3.0 LIMITING CONDITION FOR OPERATION (LCO) APPLICABILITY

STP DEP 16.3-1

FIGURE B3.3.1.4-1, ESF ACTUATION CHANNNEL STRUCTURE FOR CONTAINMENT ISOLATION, ESF SUPPORT

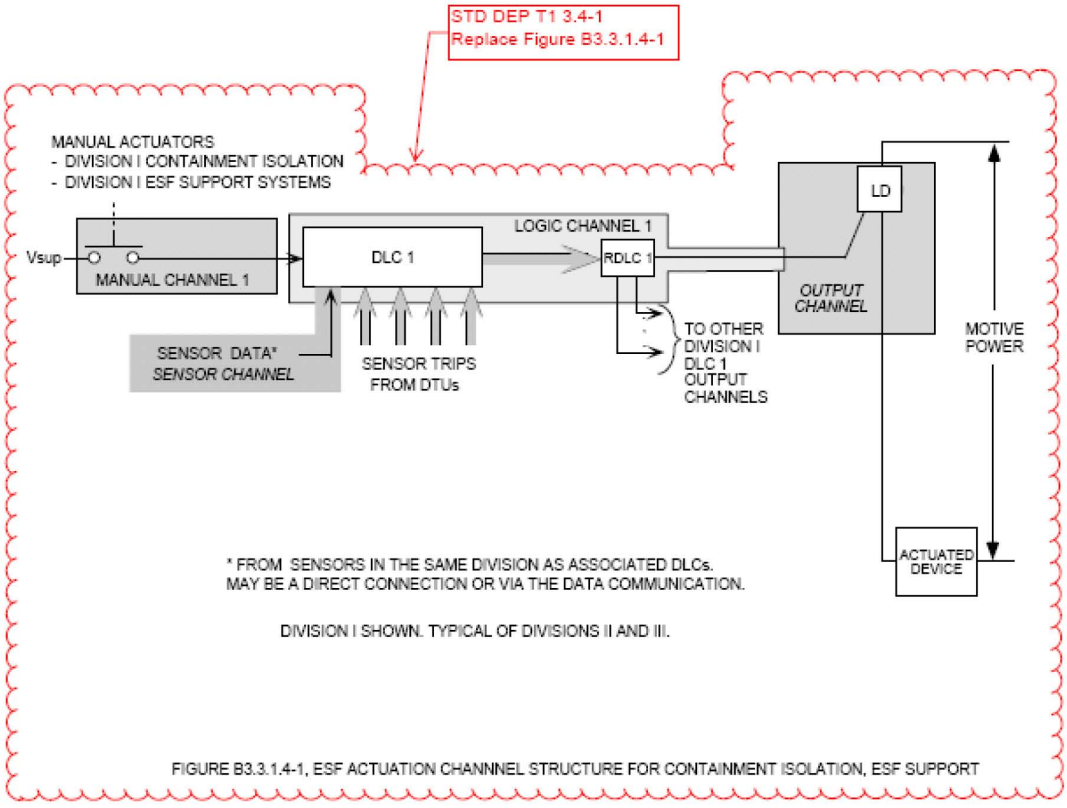
The channel structure for the channel types covered by this LCO are depicted in Figures B 3.3.1.4-1 through B 3.3.1.4-~~*4*~~5*. The channel structure in these Figures is similar with the basic structure as shown in Figure B 3.3.1.4-1. The channel characteristics shown in the* Figures ~~*Figure B 3.3.1.4-1*~~ *are:*

Figure B 3.3.1.4-1 (Containment Isolation, ESF Support Systems);

FIGURE B3.3.1.4-2, ESF ACTUATION CHANNEL STRUCTURE FOR LPFL B, C, HPCF B, RCIC

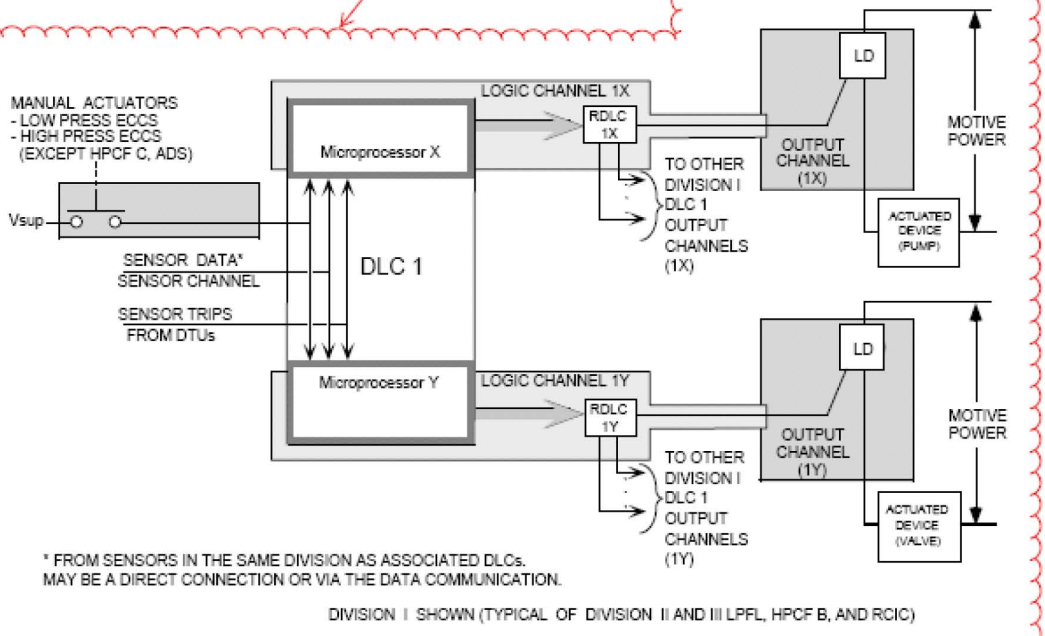
STD DEP T1 3.4-1
Replace Figure B3.3.1.4-2

FIGURE B3.3.1.4-3, ESF ACTUATION CHANNEL STRUCTURE FOR HPCF C

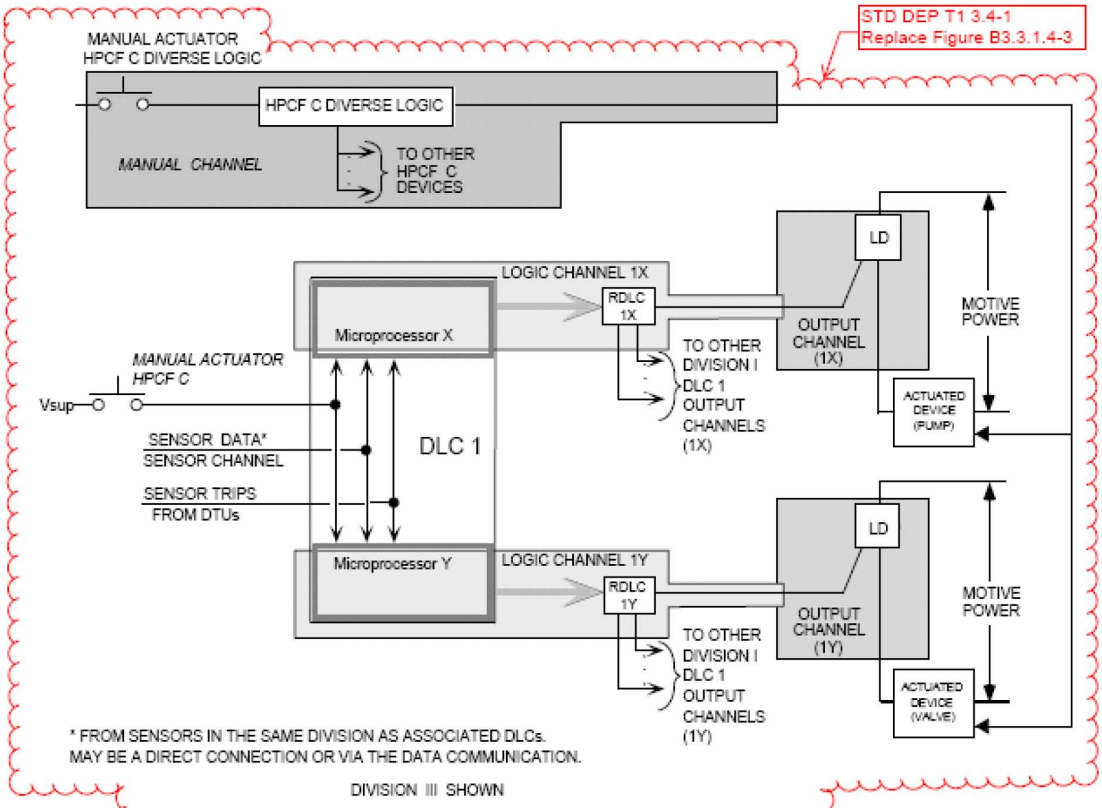
- Figure B 3.3.1.4-3 shows the hardwired manual channel for HPCF C diverse logic which applies only to division III.

The HPCF C Diverse Logic *Manual Initiation channel completely bypasses the SSLC channels (see figure B 3.3.1.4-3) and provides direct control of the actuated devices. One manual pushbutton causes HPCF C to align for injection and initiates the pump start sequence.*

FIGURE B3.3.1.4-4, ESF ACTUATION CHANNEL STRUCTURE FOR ADS

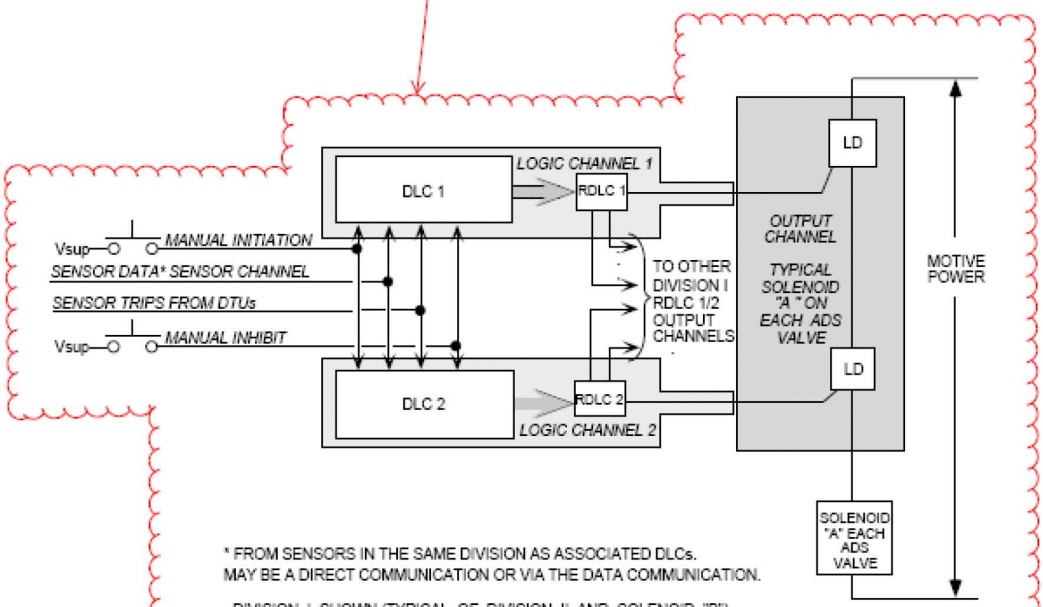
STD DEP T1 3.4-1
Replace Figure B3.3.1.4-4

FIGURE B3.3.1.4-5, ESF ACTUATION CHANNEL STRUCTURE FOR RCW/RSW ISOLATION

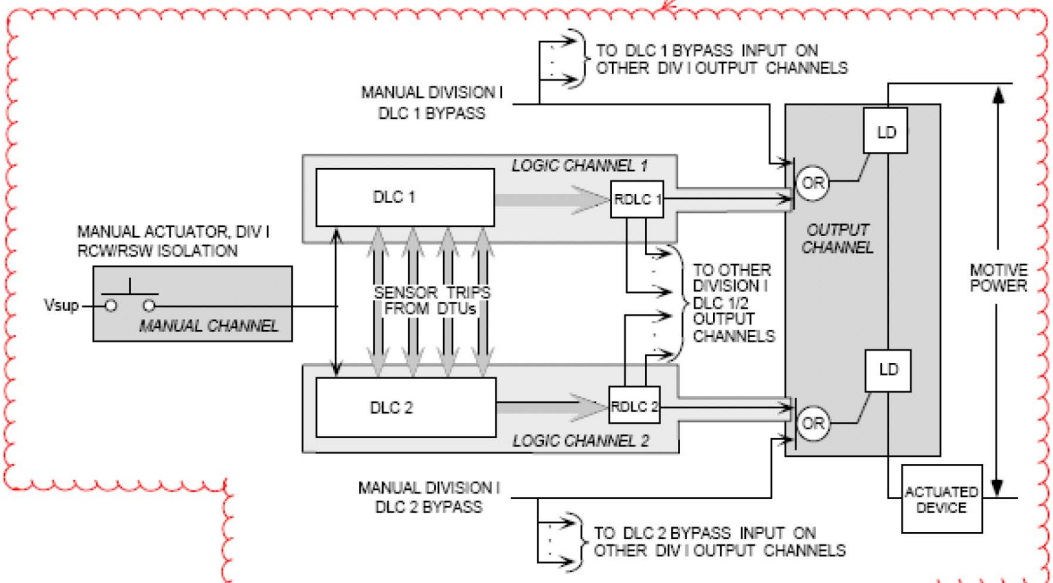
Figure B 3.3.1.4-5 (RCW/RSW Isolation);

STD DEP T1 3.4-1
Add Figure B3.3.1.4-5
